STATE OF MAINE
DEPARTMENT OF TRANSPORTATION
16 STATE HOUSE STATION
AUGUSTA, MAINE
04333-0016

April 15, 2008
Subject: **Bethel**
Pin No.014448.10
Amendment No. 1

Please make the following changes to the Bid Documents:

REVISED MECHANICAL PART PLAN ~
UTILITY ROOM A108 - E1, SHEET M-100

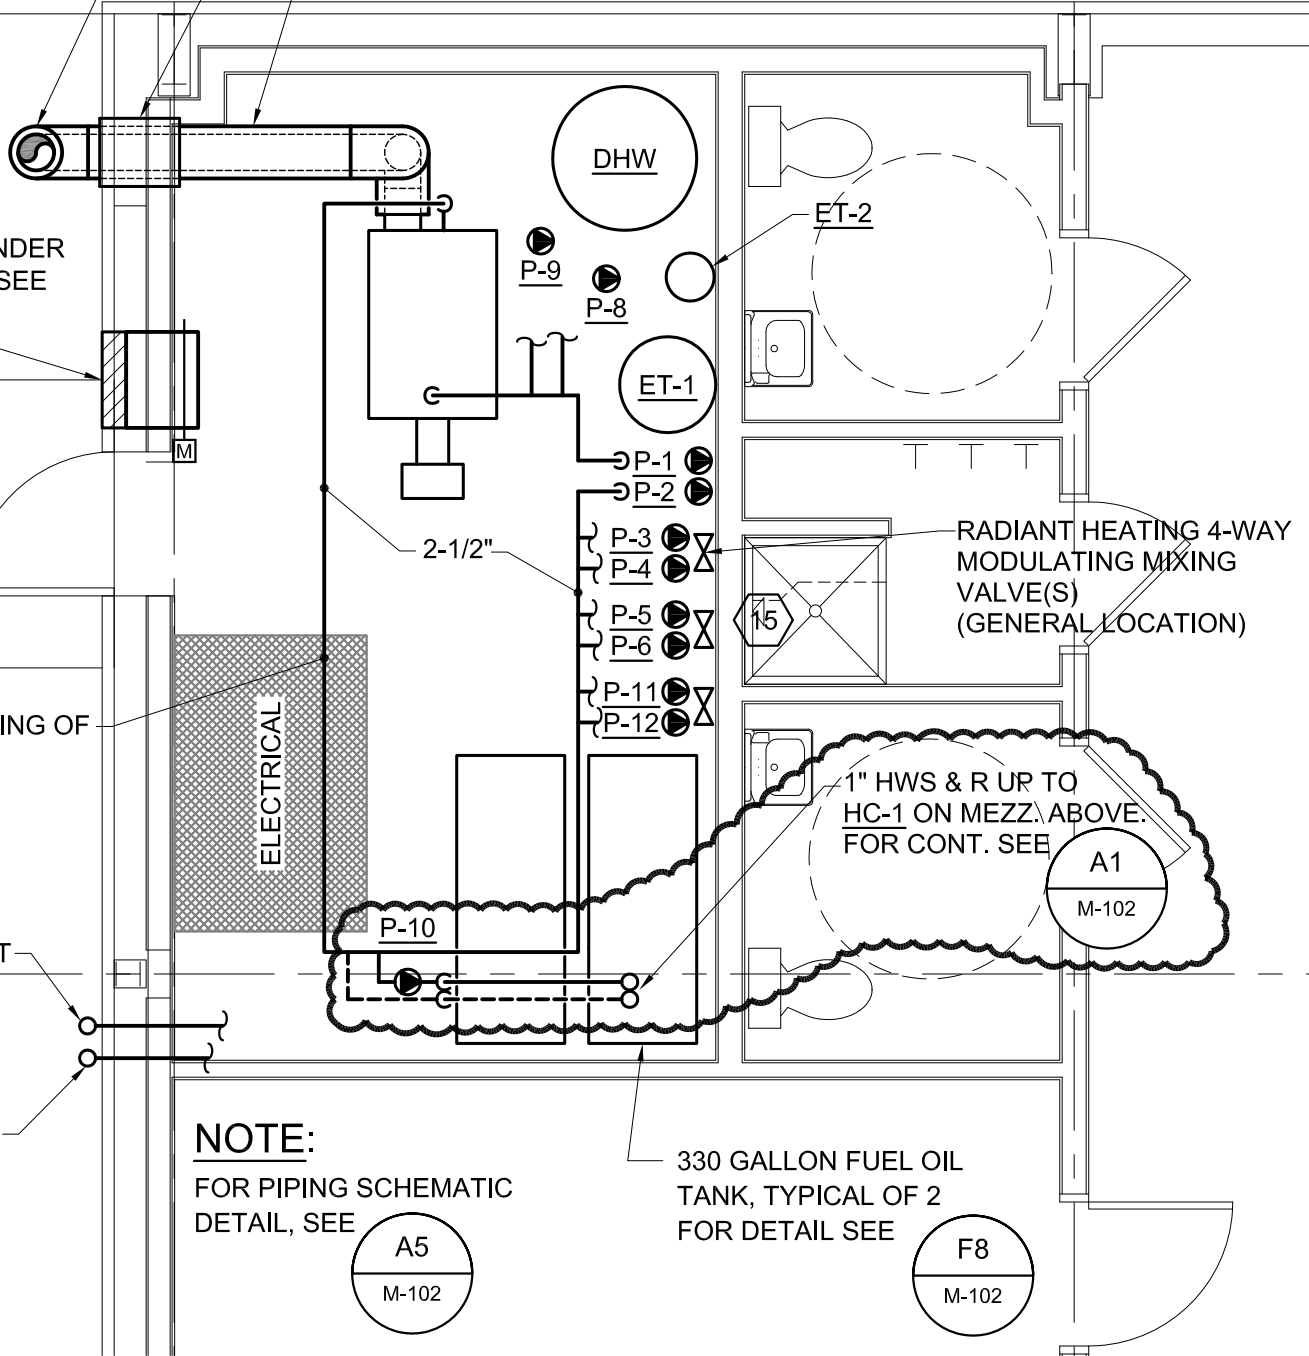
3. On Plan Sheet M-100, at Mechanical Room Part Plan E1, refer to Sketch SKM-01, attached for revisions.
4. On Plan Sheet M-102, at Mezzanine Plan A1, refer to Sketch SKM-02, attached for revisions.

REVISED MECHANICAL PART PLAN ~ HVAC EQUIPMENT MEZZANINE A202
A1, SHEET M-102

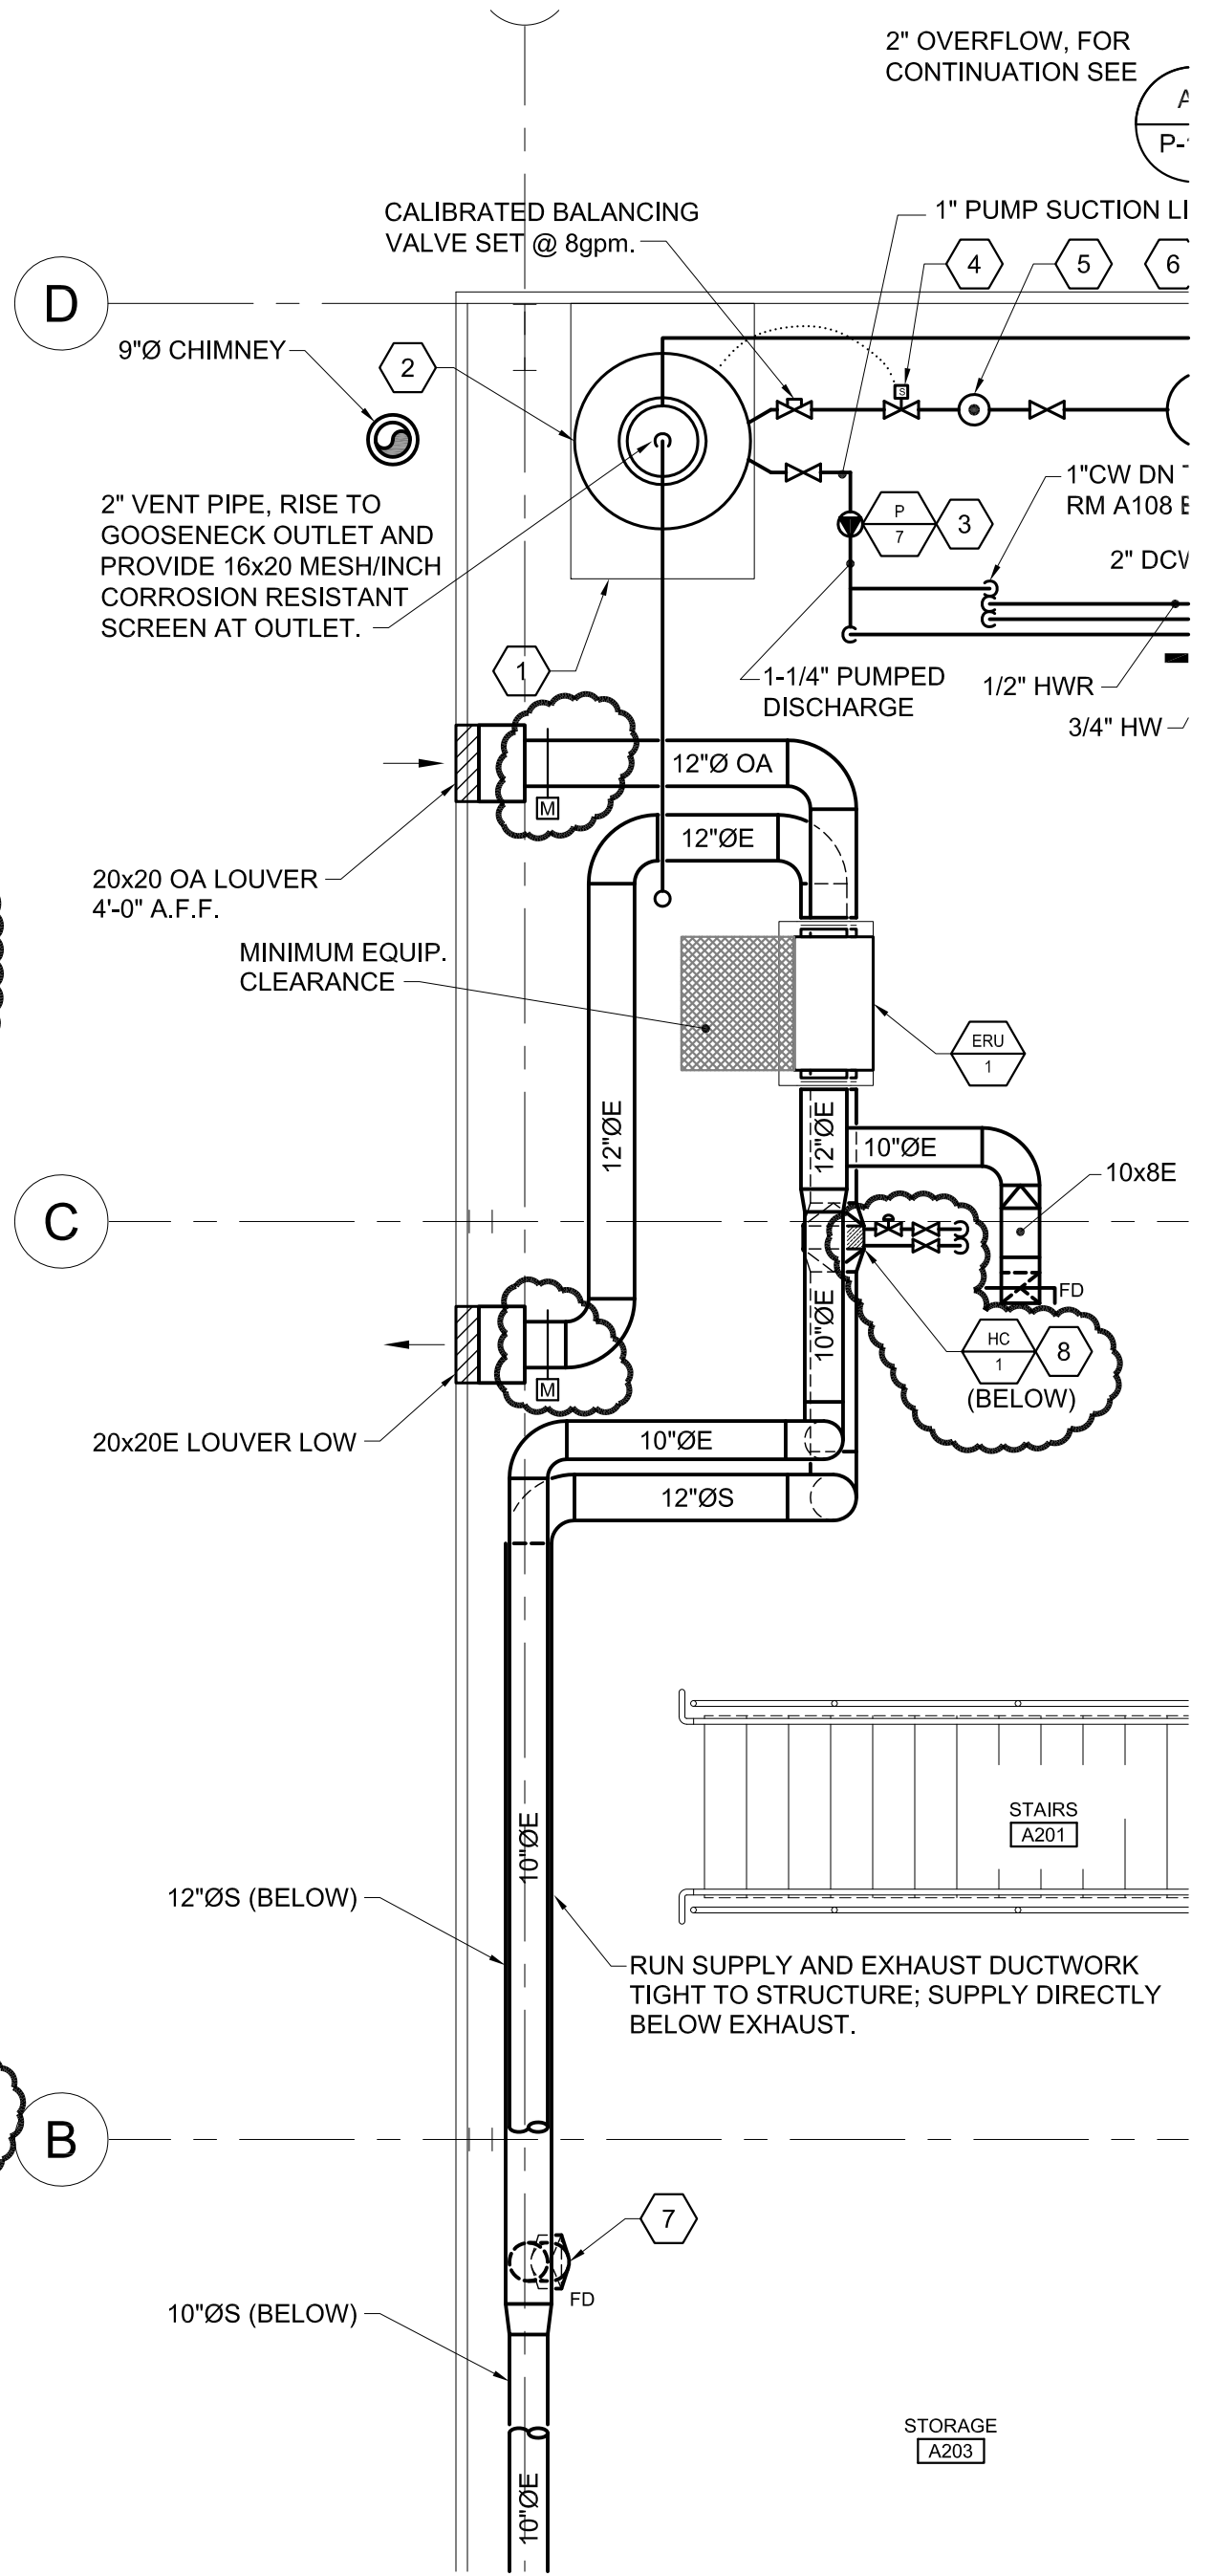
4. Vapor Retarder: All joints shall be sealed vapor tight per manufacturer's recommendations.
 5. Finish: None."
13. In Specification Section 15940 SEQUENCE OF OPERATIONS, Part 1.5 ENERGY RECOVERY UNIT (ERU-1) SEQUENCE; **ADD** The following: "C. ERU-1 OA and EA motor operated dampers shall open 100% when unit is enabled and close 100% when unit is disabled." (Refer to Sketch SKM-02, attached)
